ADMINISTRATIVE AMENDMENT

Site Plan Comparison Exhibit

DESERT SPRINGS CHURCH - EXPANSION
705 Osuna Road, NE, Albuquerque, NM 87113

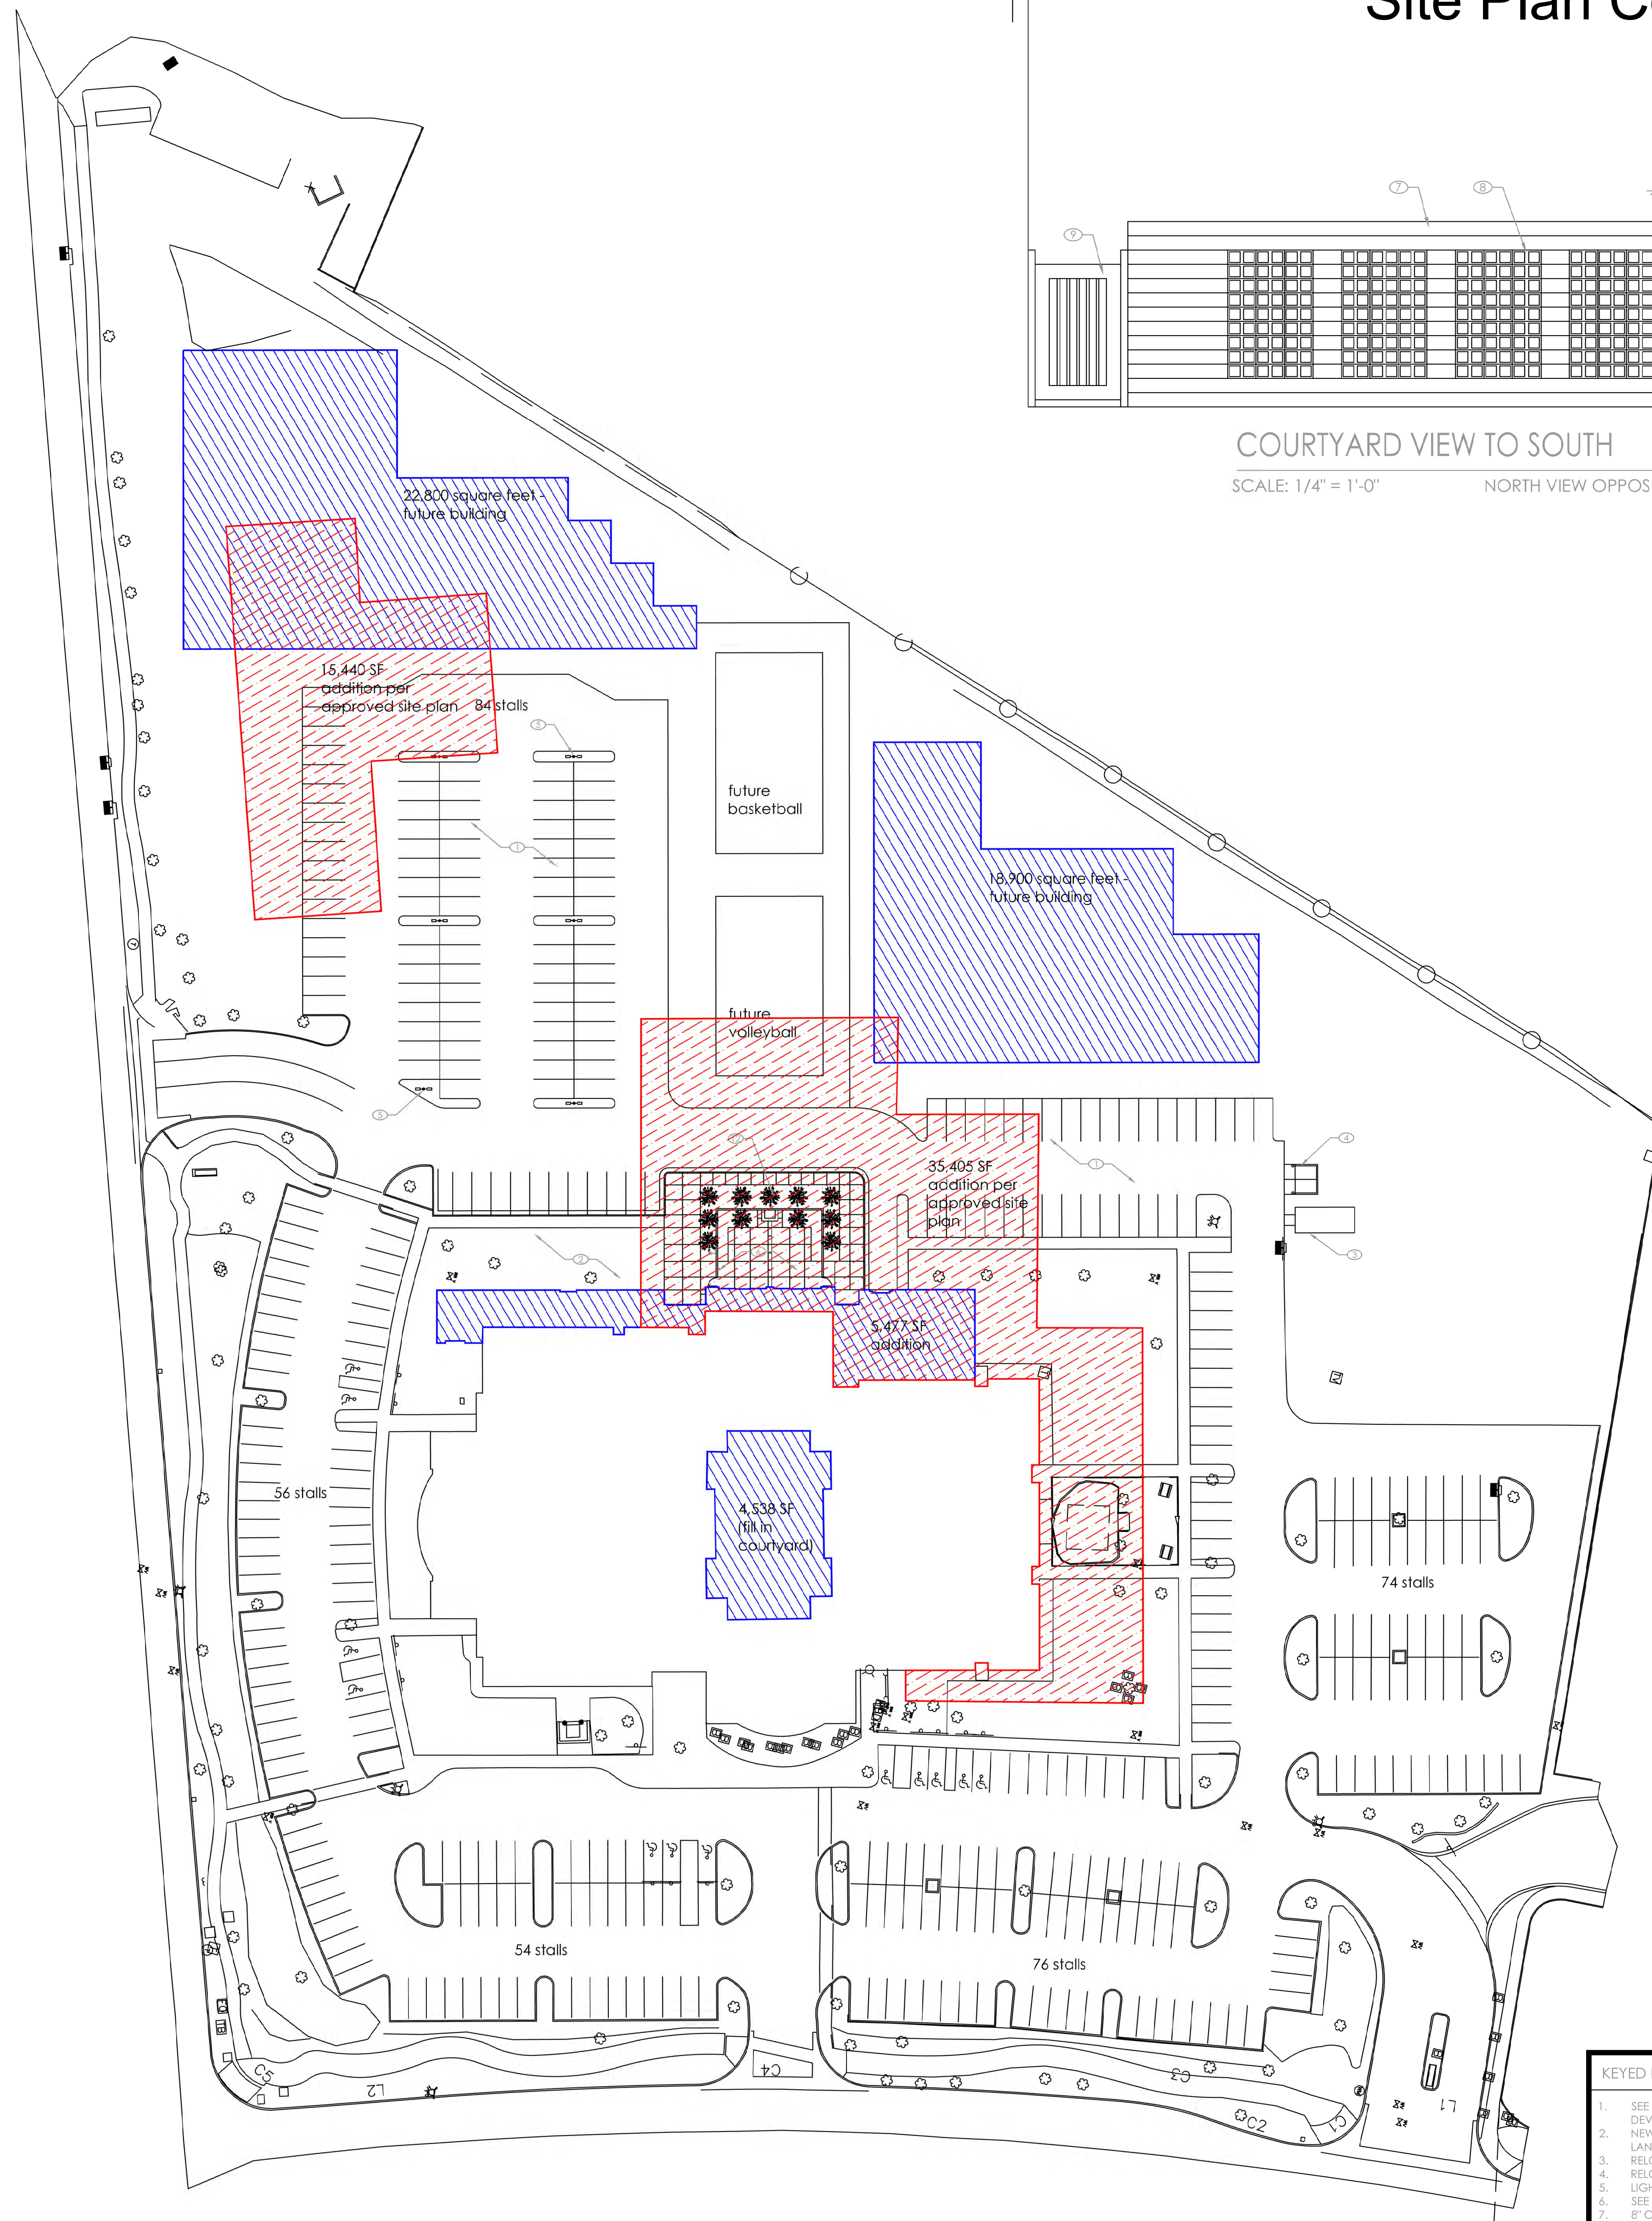
ORIGINAL APPROVAL	
	Phase 1 Building	40,253 SF
	Proposed Additions	35,405 SF
	Proposed New Buildings	15,440 SF
	Total Buildings	91,098 SF
	PROPOSED	
	Phase 1 Building	40,253 SF
	Proposed Additions	10,015 SF
	Proposed New Buildings	41,700 SF
	Total Buildings	91,968 SF
